NUREG-1437, Supplement 30
Vol. 2

**Generic Environmental
Impact Statement for
License Renewal of
Nuclear Plants**

**Regarding
Vermont Yankee Nuclear Power Station**

Final Report – Appendices

Figure 1. Percent composition of numerically important species collected downstream of Vernon Dam [from Table 5-14 of the 316(a) Demonstration, April, 2004].

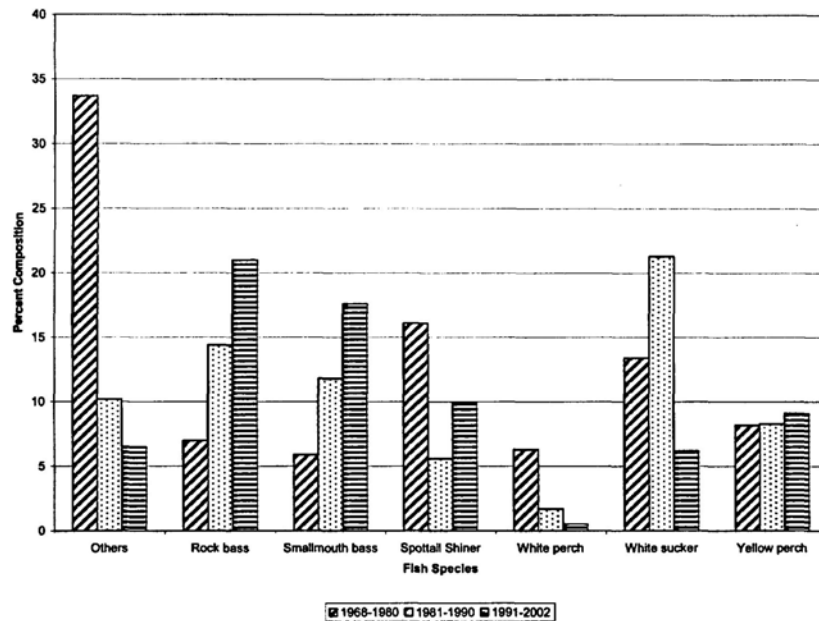
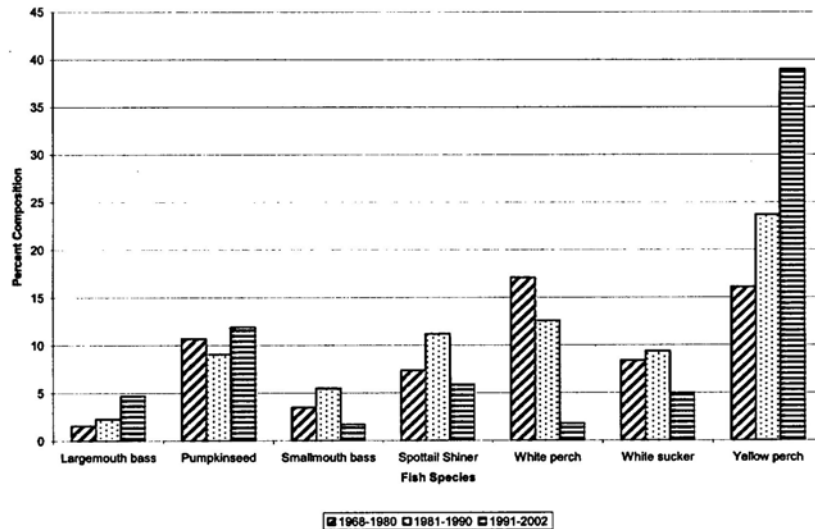
Page 4-17, lines 11-13: Although Entergy believes no observable adverse impacts to any fish species or to the overall fish community of Vernon Pool due to entrainment by VY has been demonstrated, the fact remains that Figures 1 and 2 above show a decline in the percent composition of white sucker and white perch in the LVP, and both of these species do show up in entrainment collections. Whether this relationship is causal or coincident is unknown.

Figure 2. Location of Vermont Yankee Nuclear Power Station, 6-mi Region (Source: Entergy 2006b)

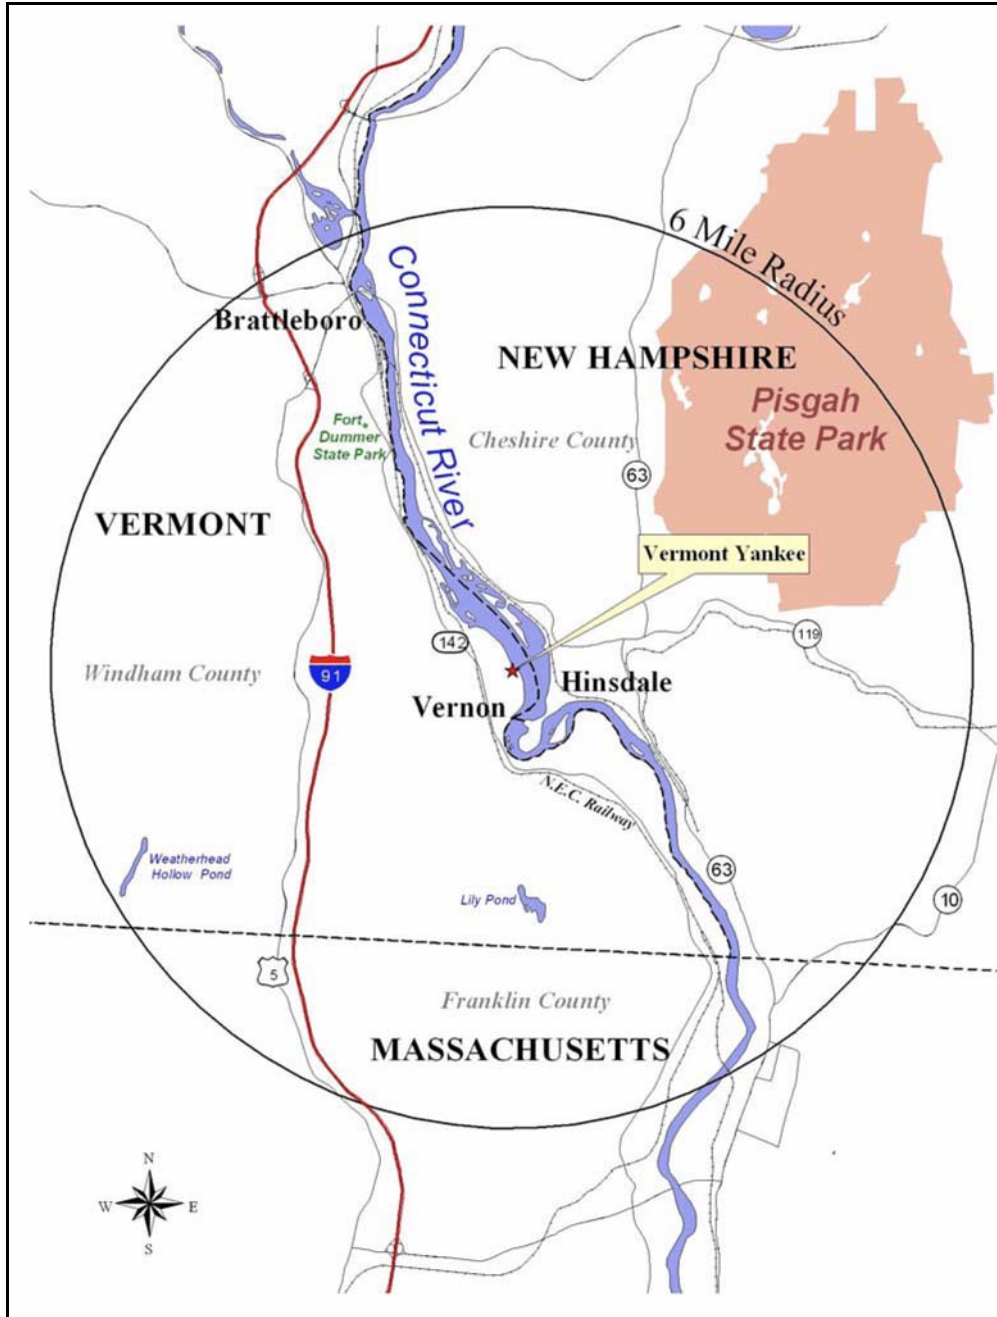
Comment: Page 2-6, lines 1-5: Text generally describes land uses within a 5 mile radius of VYNPS. On the other hand, Figure 2-2 (pg. 2-3) illustrates a 6 mile radius. (CCC-15)

Response: *There is no correspondence between the textual description on page 2-6 and Figure 2-2. There is also no reference to Figure 2-2 in the mentioned text. No change has resulted in response to this comment.*
